MIDLAND UNITS 1 & 2
JOB NO. 7220

REVIEW OF U.S. TESTING
FIELD AND LABORATORY CONSTRUCTION
TEST DATA ON SOILS USED AS FILL

PREPARED BY
BECHTEL POWER CORPORATION
JUNE 12, 1979

FIGURE 9

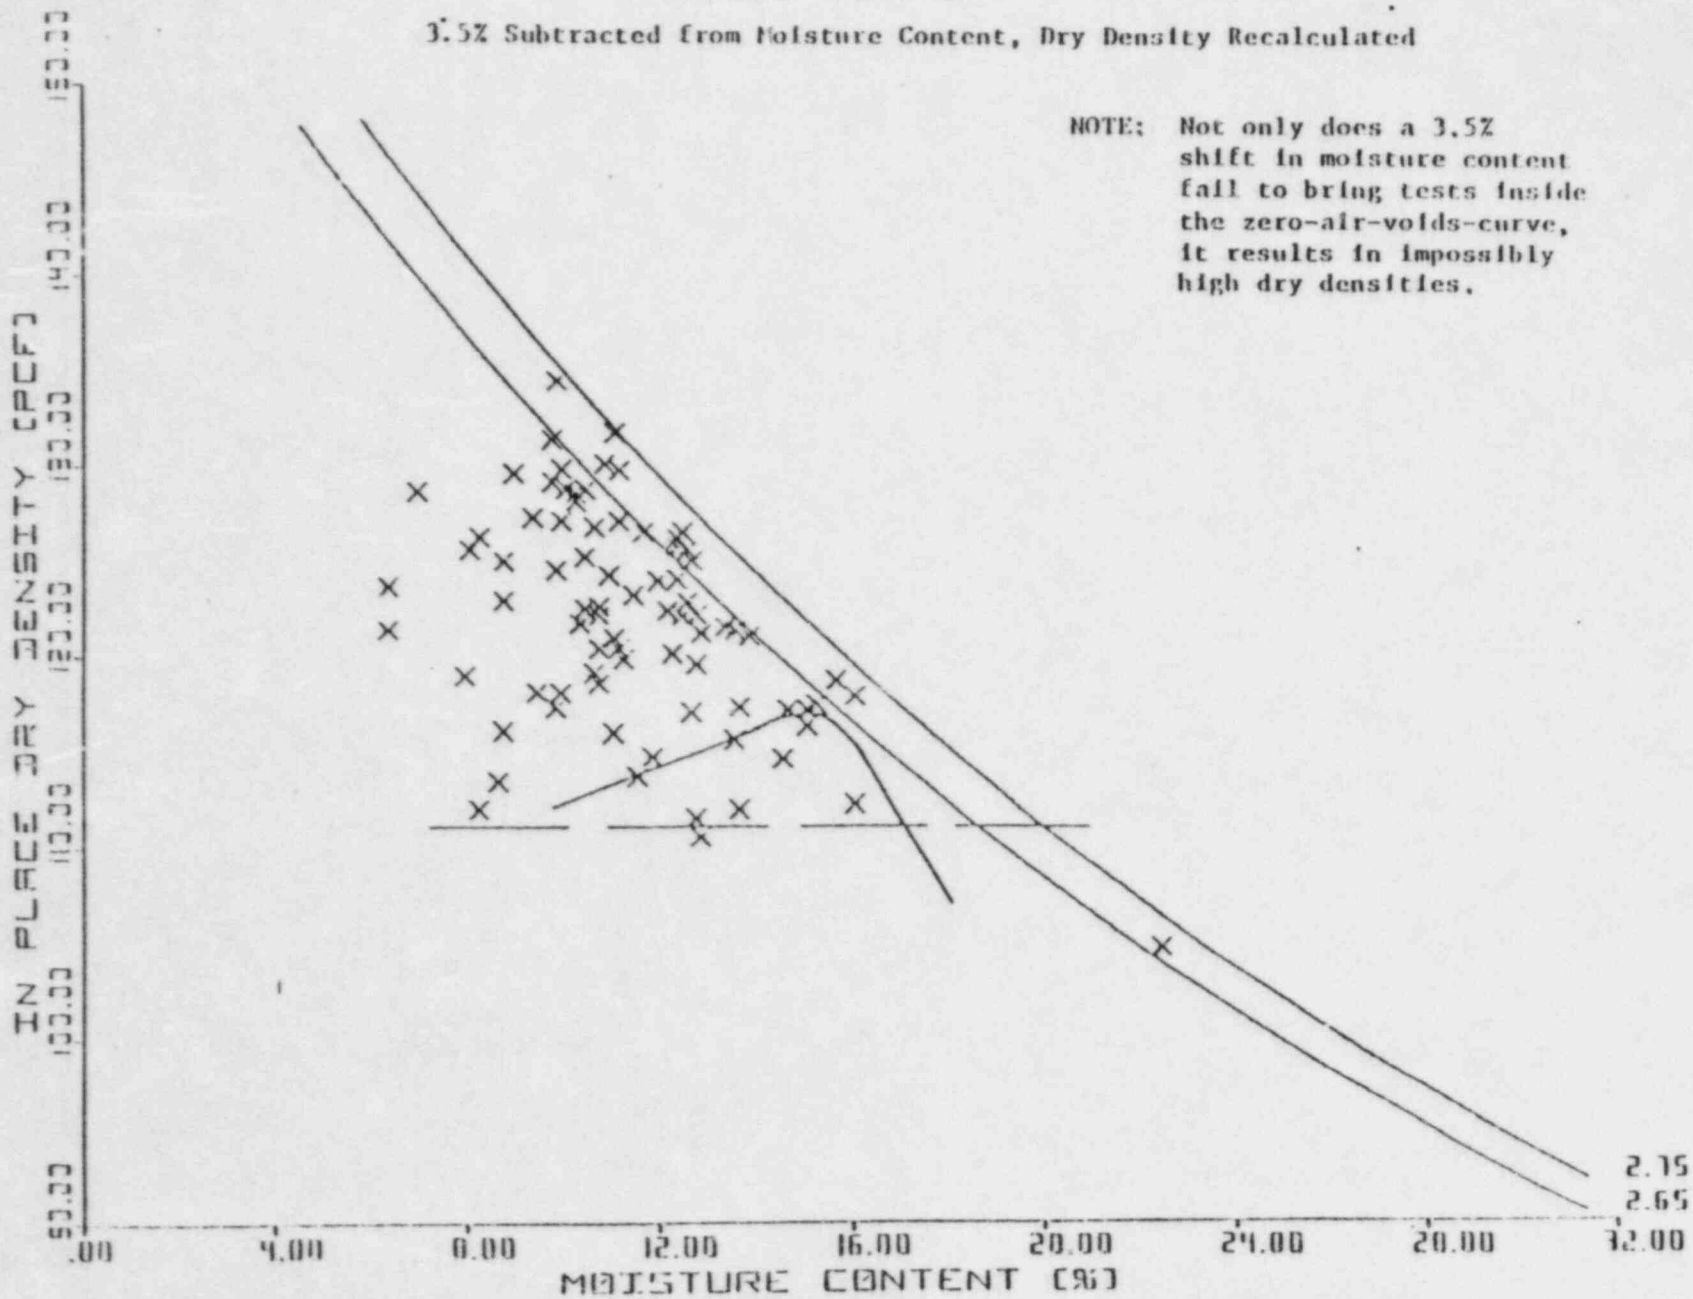
In a letter from U. S. Testing to Bechtel (dated May 30, 1974), the average deviation of the nuclear device from oven-dry moistures was +.12% for a set of 30 tests. However, the standard deviation is 1.77% for the data with the range of differences being from - 3.2% to +3.9%. Thus, accuracy of the nuclear device is questionable, and could translate into errors of roughly ± 4 pcf in the dry density calculation. (It should be noted that errors in the moisture content tend to shift the position of test results on a moisture density plot approximately parallel to the zero air voids curve, assuming the in-place wet density is correct, and thus do not explain the large number of points which plot outside this limit. See Figure 9).

NOTE: Not only does a 3.5% shift in moisture content fail to bring tests inside the zero-air-voids-curve, it results in impossibly high dry densities.

Contrary to the assumption regarding figure 9 with its "impossibly high dry densities" current test data closely resembles this graphical representation.

FIGURE 10
CHANGE IN RELATIVE DENSITY SCALE FROM DRY TO WET METHODS
OF OBTAINING MAXIMUM DENSITY, BASED ON RECENT LAB RESULTS

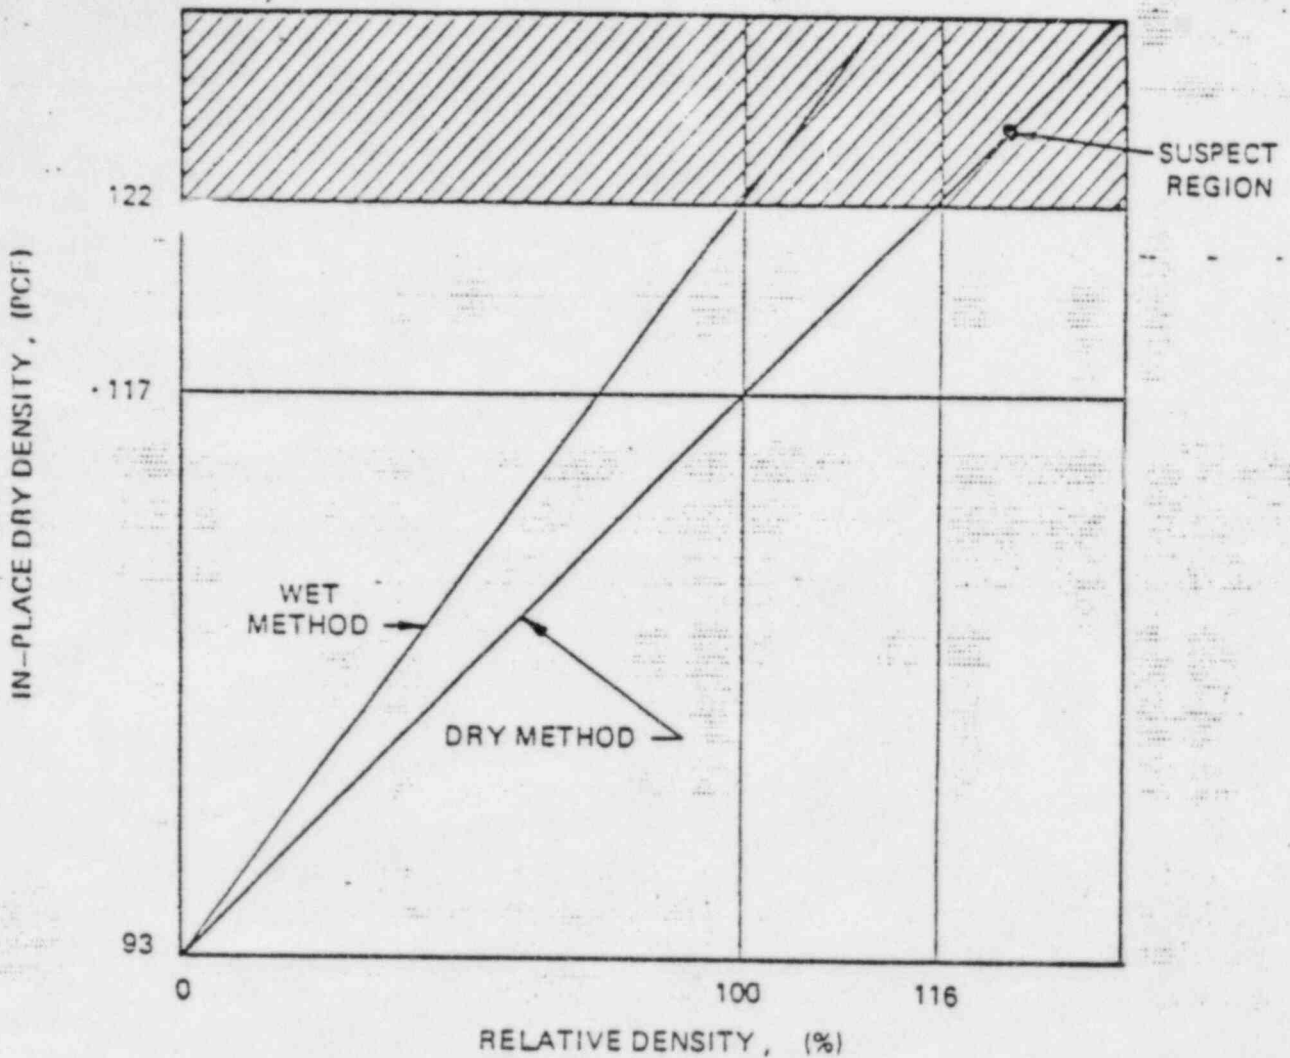
NOTE: VALUES FOR DRY DENSITY ARE TYPICAL OF A RANDOM FILL SAND. ANY TESTS SHOWING MORE THAN 117% RELATIVE DENSITY WOULD BE SUSPECT IN THIS EXAMPLE. STRUCTURAL SANDS TEND TO SHOW ONLY 2 OR 3 PCF INCREASE IN MAXIMUM DENSITY AND THUS RESULTS AT MUCH LOWER RELATIVE DENSITY WOULD BE SUSPECT, SAY 105 - 110 PERCENT

FIGURE 1

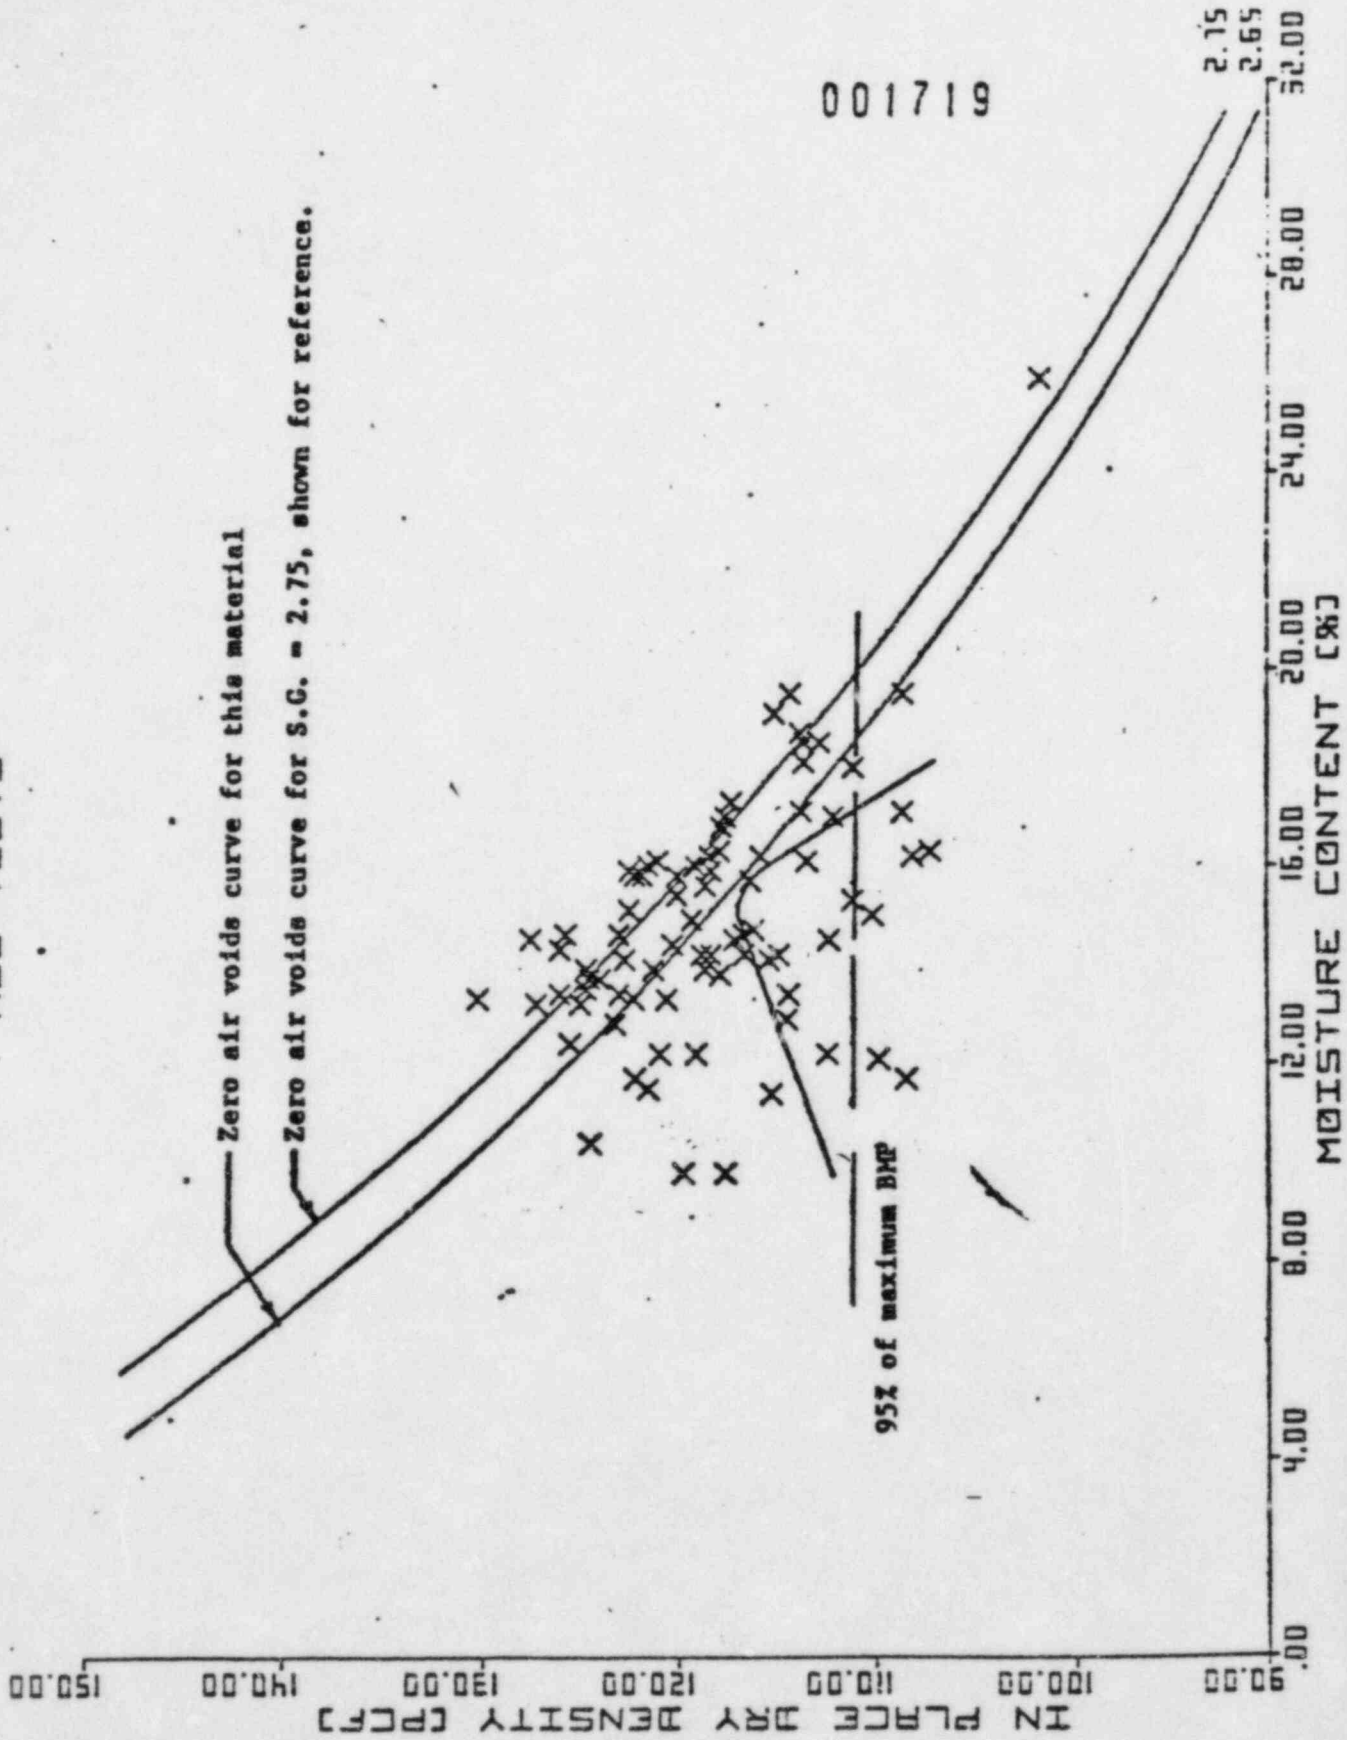
band of specific gravity values represented in the Bechtel report figure 1 results in a 49 percent reduction of theoretically impossible results. The remainder of these test points falling above zero-voids line will be discussed in Section 6. However, specific gravity values from 2.57 to 2.82 for soil fractions are documented for material on this project.

Also, referring to Figure 1 it would appear that soil density varied widely. Specifications called for compactive effort results as defined by ASTM D 1557 which is 56,255 ft-lb/ft³ energy. This was modified to a laboratory test compactive effort of about 20,000 ft-lbs/ft³ energy, often referred to as Bechtel Modified Proctor (BMP). Laboratory compaction test curves should be related to the same effort as that called for in the field for use in comparing with field density tests to determine percent compaction. According to plots of field data shown on Figure 1, density varied from about 108 lb/ft³ to about 130 lb/ft³. It is doubtful that the soil classification or other properties would be similar for such a wide variation in density. It is noted that 100 percent of modified Proctor (ASTM D 1557) which is difficult to obtain, is rated at 56,255 ft-lb/ft³ energy. The curve plotted on Figure 1 is at about 20,000 ft-lb/ft³ energy. For comparative purposes it was determined by U. S. Testing in 1974 that 100 percent of specified effort (20,000 ft-lb/ft³) is approximately equal to 95 percent of the maximum density as determined by ASTM D 1557 (56,255 ft-lb/ft³) Reference Figure 8.

FIGURE 7: WINDOWS OF ACCEPTABILITY (A) BASED ON BMP
SPECIFICATION (B) REGARDLESS OF EXACT WORDING OF
SPECIFICATION

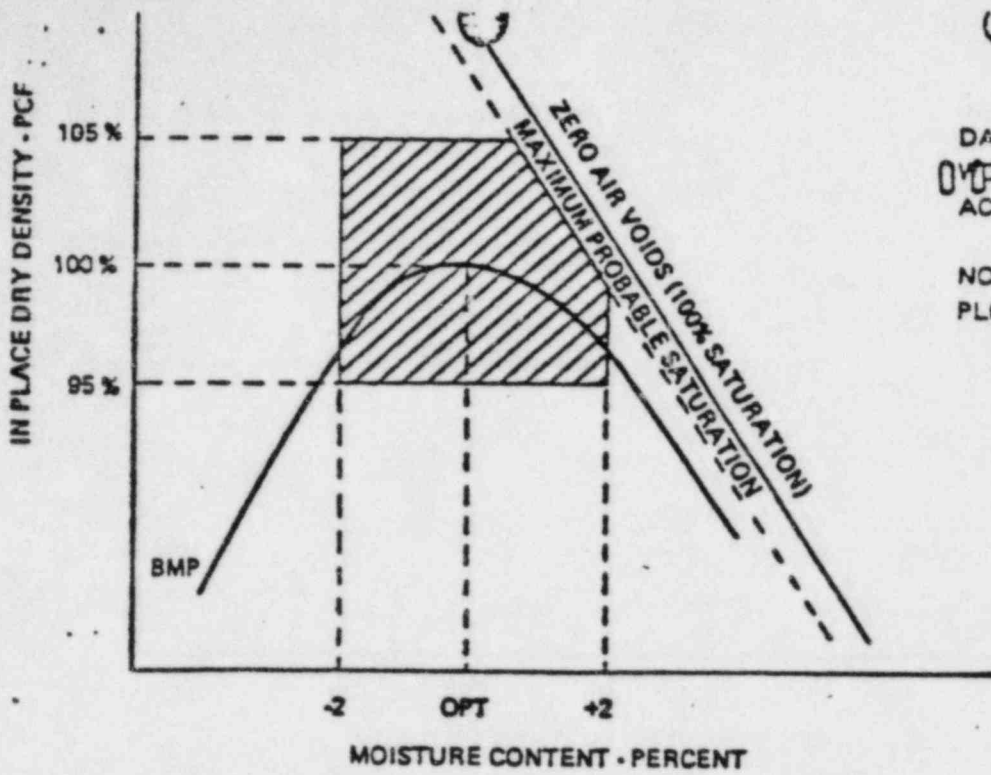
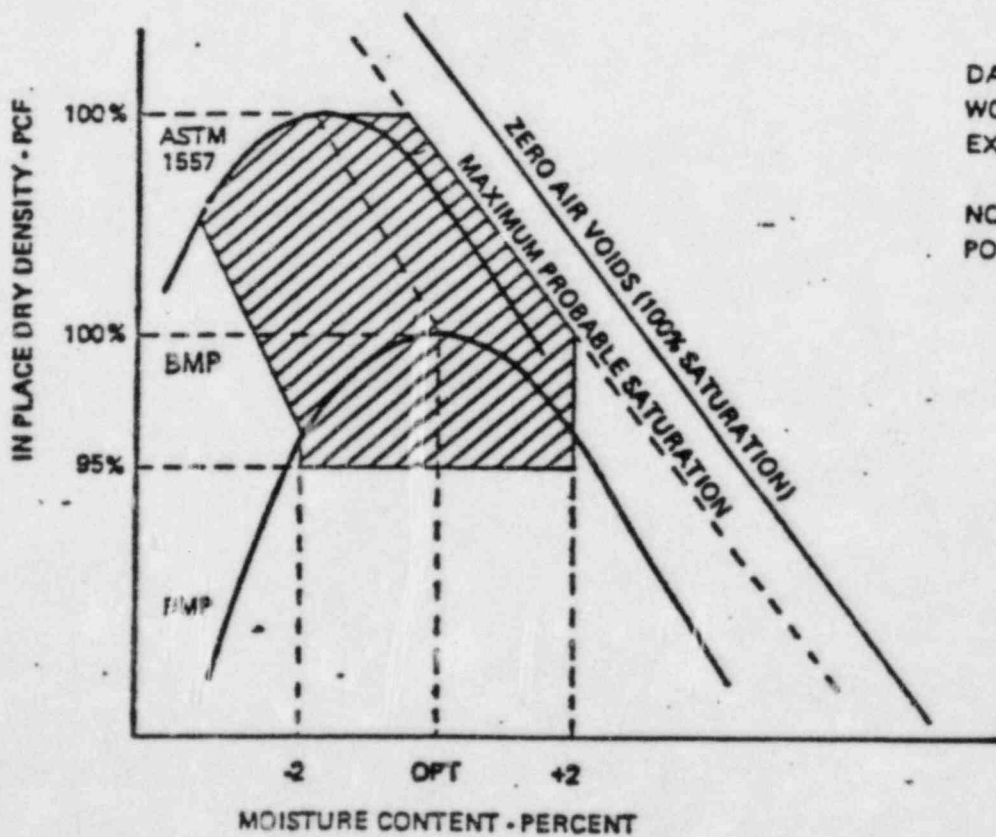
For a field test result to be valid as well as "Passing" it must fall within a well defined area on the plot containing the laboratory compaction curve. This area or window of acceptability is shown for a hypothetical compaction curve on Figure 7a that would meet requirements of Specification 7220-C-210. It is defined by horizontal lines at 95 percent and 105 percent of specified density, vertical lines through ± 2 percent of optimum moisture content, and a line parallel to the zero voids line indicating saturation about half way between the compaction curve and 100 percent saturation (zero air voids curve). The practical upper limit of 105 percent of specified density is not defined in the specifications. It was arbitrarily chosen as numbers greater than this give increasingly invalid comparisons between field test results and the specified laboratory compaction test curve. Therefore, if all data points fall within the defined window there would be no reason to assume that they are wrong. However, when many data points fall outside the designated area there is something wrong with the information and then all data points become suspect. A review of all data indicates that about 25 percent of the cohesive soil test results fall within this area.

Figure 7b shows an area where field test results would be acceptable, in theory even though not in strict accordance with the specifications. Figure 7b was arrived at by expanding Figure 7a to include test results up to a compactive effort related to ASTM D 1557 (56,255 ft-lb/ft²), which is considered to be a practical upper limit. About 40 percent of all cohesive soil test results would plot in this area.

DATA POINTS THAT PLOT IN SHADED AREA
WOULD BE GENERALLY ACCEPTABLE
ACCORDING TO SPECIFICATIONS

NOTE: ABOUT 25% OF ALL FIELD DATA
PLOTS IN THE SHADED AREA

DATA POINTS THAT PLOT IN SHADED AREA
WOULD BE ACCEPTABLE REGARDLESS OF
EXACT SPECIFICATION WORDING

FIGURE 9

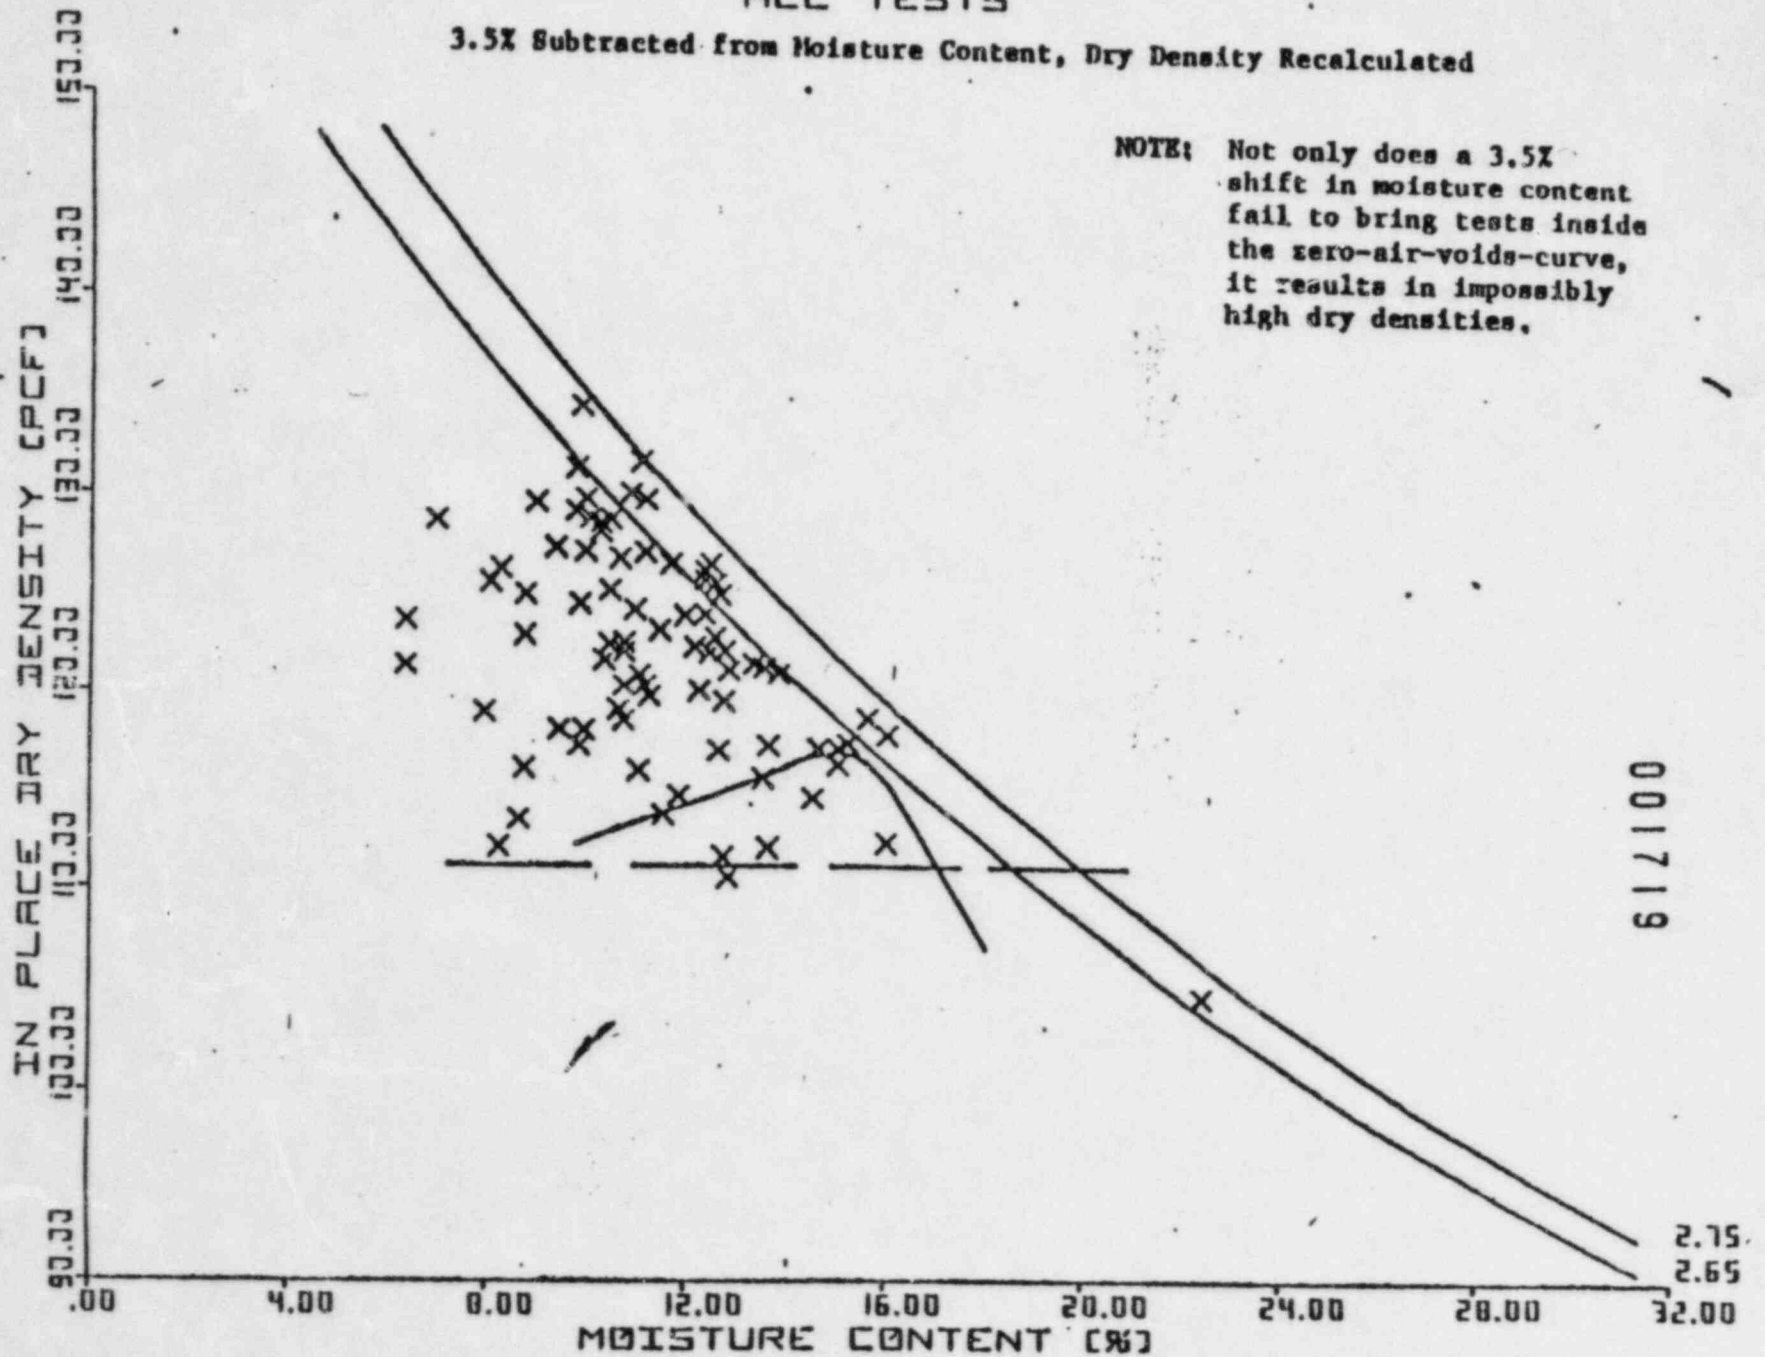
NOTE: Not only does a 3.5% shift in moisture content fail to bring tests inside the zero-air-voids-curve, it results in impossibly high dry densities.
